CHILDREN'S HOSPITAL
OF ORANGE COUNTY

TOWER II

LEVEL 7 REFLECTED
CEILING PLAN AREA - A

A4.7A

A6 AREA A

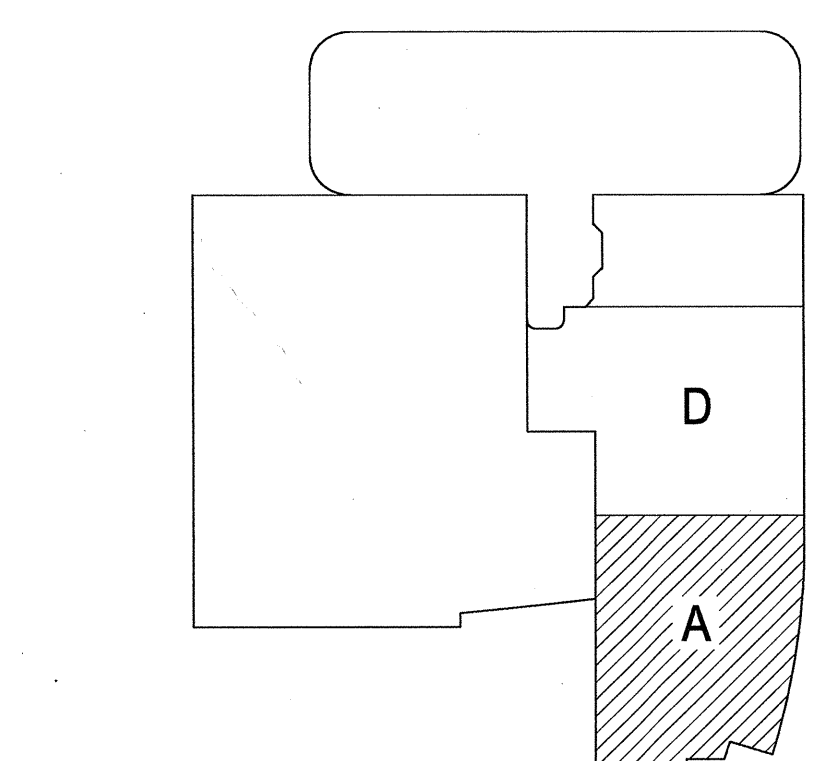
RFI 1018
Refer to electrical lighting plans for light fixture locations in shell space.

RFI 4495
See detail E5/A8.1 for alignment of soffit with exterior metal panels

RFI 4175
Gyp board to be used for soffits see detail B3/A10.1
